REGIONAL REVIEW FINDING

Submitting Local Government: City of Milton
Name of Proposal: Deerfield Place

Preliminary Report:	August 1, 2007	DEVELOPMENT OF REGIONAL IMPACT REVIEW REPORT	Project:	Deerfield Place # 1470
Final Report Due:	August 30, 2007		Comments Due By:	August 15, 2007

DR/ SITE PLAN

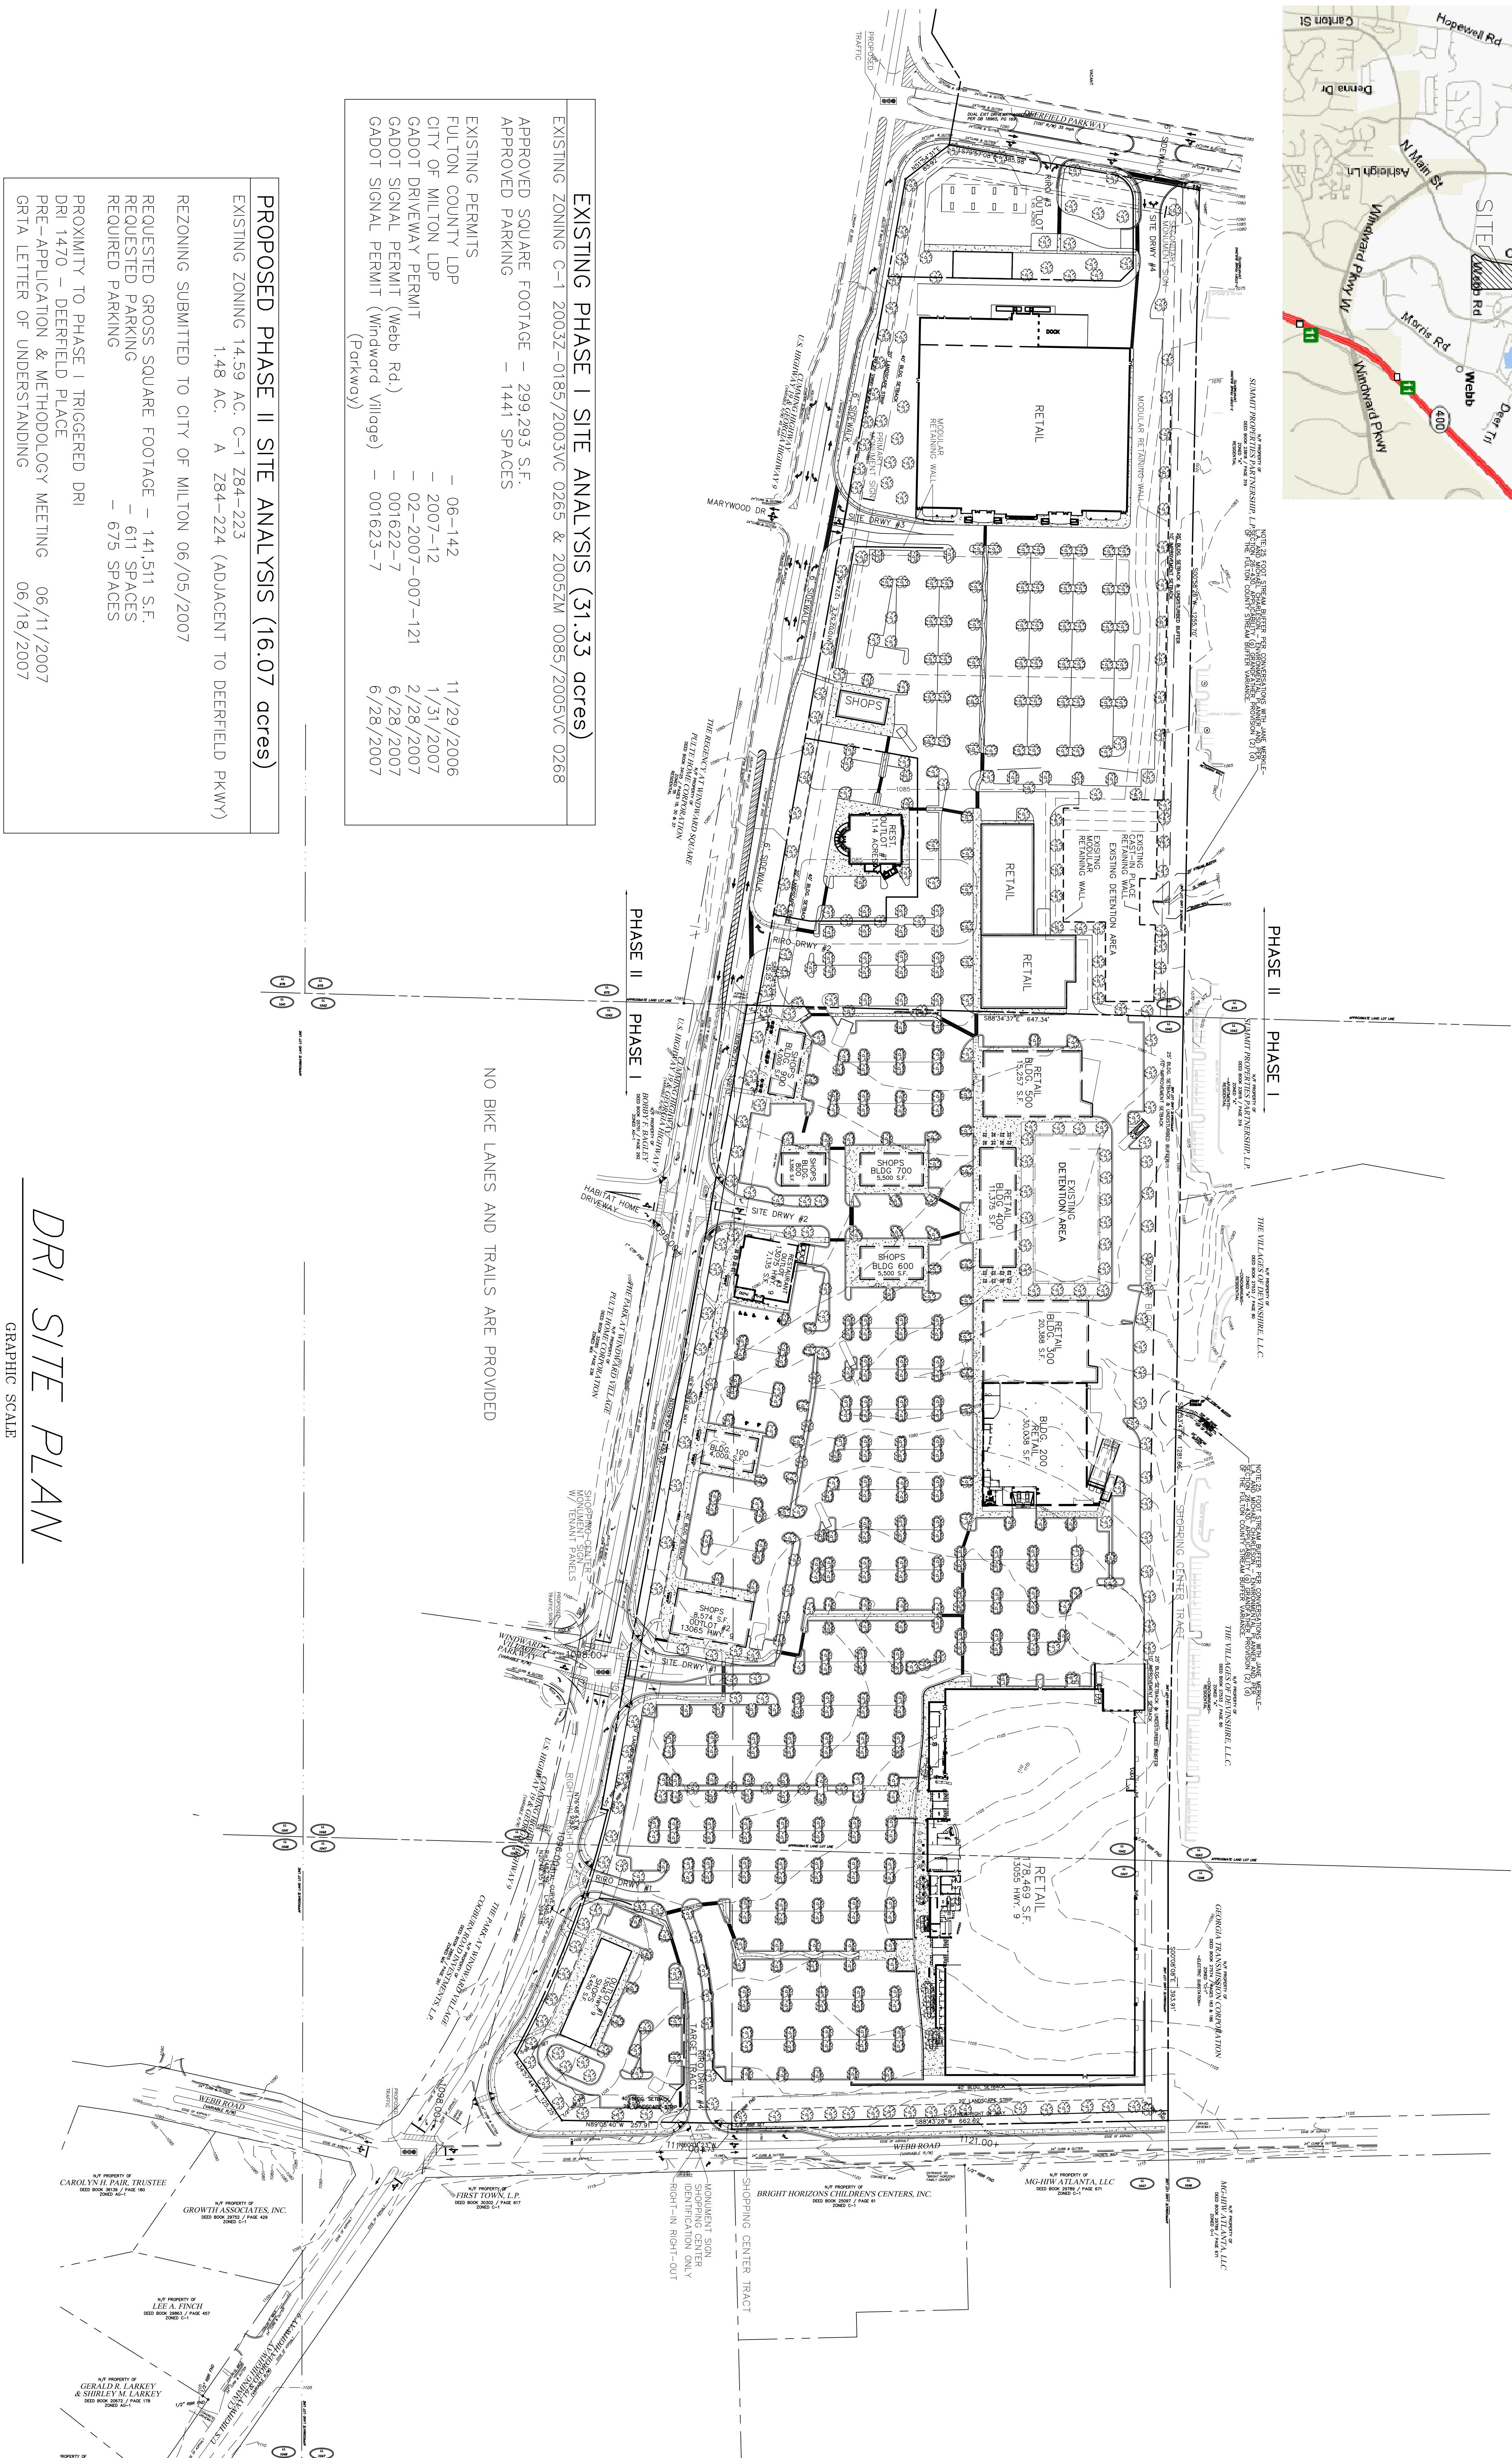
development that could result in increased pedestrian traffic. It is important to create a safe and inviting pedestrian experience within and immediately surrounding the development. This includes a pedestrian oriented street edge, wide sidewalk, pedestrian oriented main street, clearly defined pedestrian paths and crossing, landscaping, and street furniture. The proposed development includes sidewalks throughout the parking areas and sidewalk connections from State Route 9 directly to buildings entrances. The development also proposes pedestrian connections directly to the residential areas located behind the development along Webb Road and Deerfield Parkway.

Other issues raised during the review concerned building orientation, particularly along State Route 9. It is recommended that revisions to the site plan made during the permitting process include orientation of the buildings to the street rather than to the parking lot to create a street edge along State Route 9.

- Sembler is not opposed to installing pedestrian connectivity to these properties.
- The attached colored site plan shows two (2) locations for pedestrian connectivity to the east, one (1) for Camden Deerfield Apartments and one (1) for Villages of Devinshire Condominiums.
- The proposed pedestrian connections will meander through 25 – 35 feet of a natural undisturbed buffer that currently separates the properties. This area is required to remain undisturbed per the zoning and local ordinances. Ultimately, the City of Milton would have to provide approval for the paths to be built through an administrative variance or a formal zoning variance that would go through the City approval process.
